ENGINE - CASE AND VANE ASSEMBLY - HP TURBINE, STAGE 1 DUCT SEGMENTS - NOT APPLICABLE
- MOD.ENG-72-0091

V2500-ENG-72-0091

Location of stage 1 HPT duct segments
Fig.1

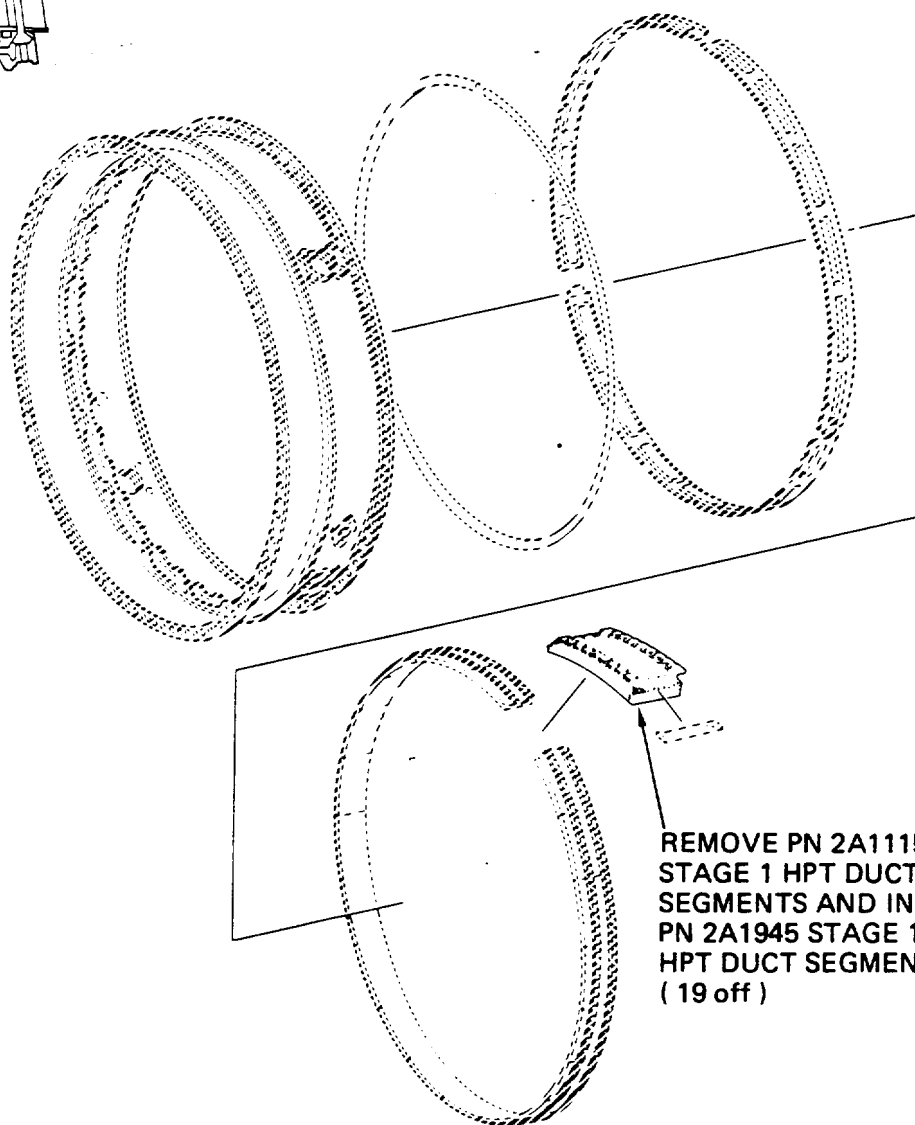
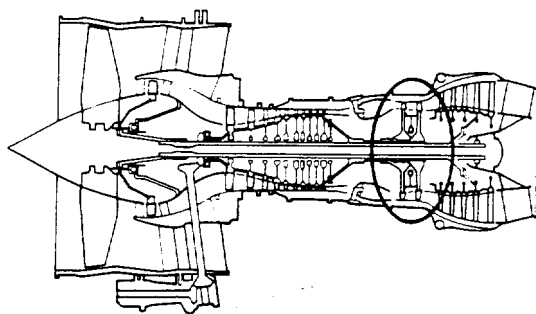
- (1) Remove the 2A1115 Stage 1 HPT Duct Segments by the approved procedure in Reference (1) Chapter/Section 72-45-20 Disassembly.
- (2) Install the 2A1945 Stage 1 HPT Duct Segments (19 off) by the approved procedure in Reference (1) Chapter/Section 72-45-20 Assembly. See Figure 1.
